# ARCHWAY BRIDGE ANTI-SUICIDE MEASURES

A design report prepared by David Richmond on behalf of the Highgate Society - November 2018

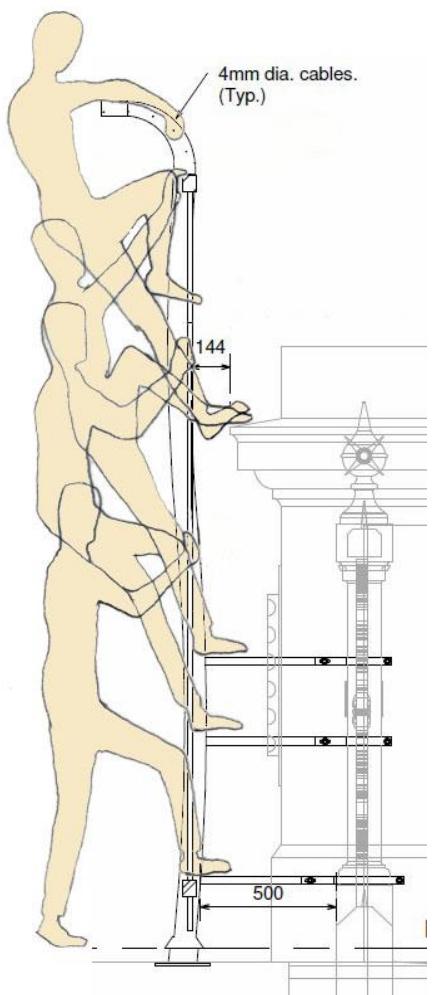
We presume that all can agree this looks more suited to a high security prison than to a grade II listed structure in a conservation area.

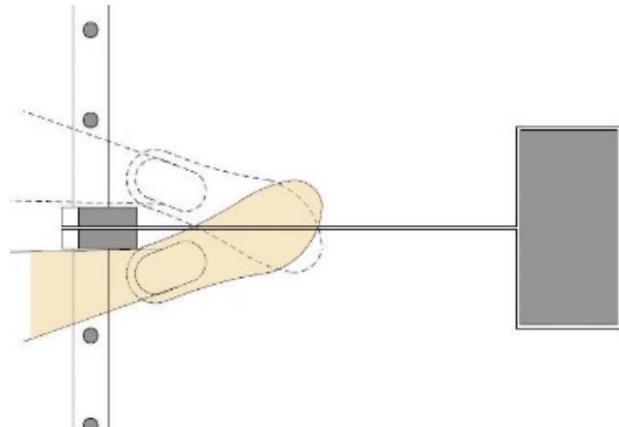
Despite the engineering led approach to this proposal there are still some possible weaknesses in the design. The vertical bars are spaced 100mm apart and are now thick enough at 20mm diameter not to bend in their height. The main support columns are fixed down onto the surface of the bridge and braced, to give them better support, using steel ‘saddle brackets’ fixed back onto the bridge balusters.

By putting one's feet between the bars and onto the bracing straps it would be possible to lift oneself up approx 1.1m above pavement level which would put the top rail of the fence within reach. From the top strap it would also be possible to get one's foot onto the edge of the plinth, getting you even higher. The vertical bars provide plenty of steady hand holds. We are not suggesting that this is then an easy way to get over the fence, particularly because of the overhanging wires but it is clear that the fence is only as good as its weakest link and we feel that these unintentional steps are a significant weakness.

Section through end panel

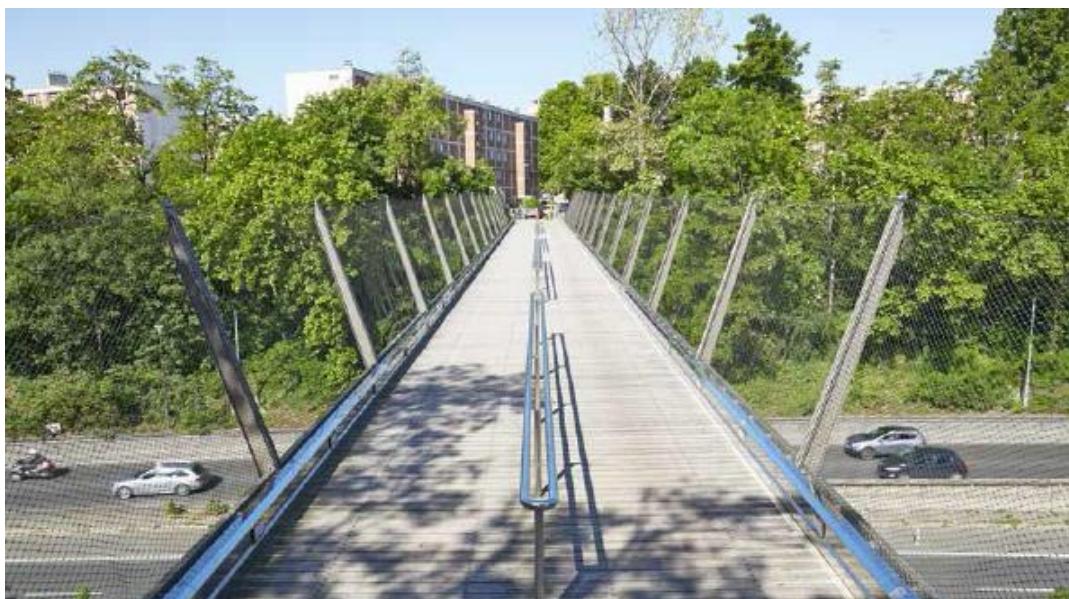
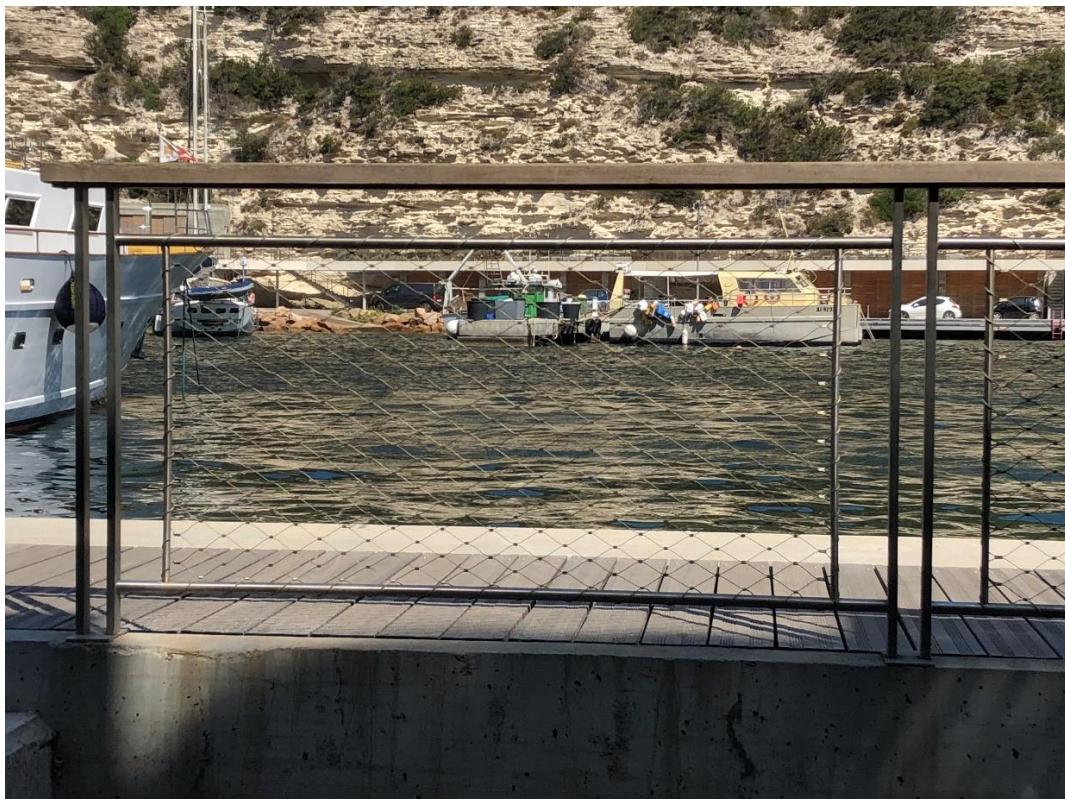
The profile of the fence at the ends, in order to remove foot and hand holds would be as shown below left. The total height is identical to the current proposal.

The section through a typical bay, middle image above, has just the curved mesh panel running between the new top rail and the top of the existing balustrade. The curved posts give the shape to the mesh stretched between them. The curved posts are supported on the ledge and held back to the existing balustrade posts using the same saddle brackets as the current proposal. In this way the existing listed structure remains unharmed.

The central pier has in the past always presented a problem but by using the mesh and this particular shape of curved post, the mesh can be connected to an oval collar around the lamp standard. Anyone attempting to climb onto the central pier will find that the mesh is too close above their heads to be able to manoeuvre their way out to the cantilevered end of the mesh.
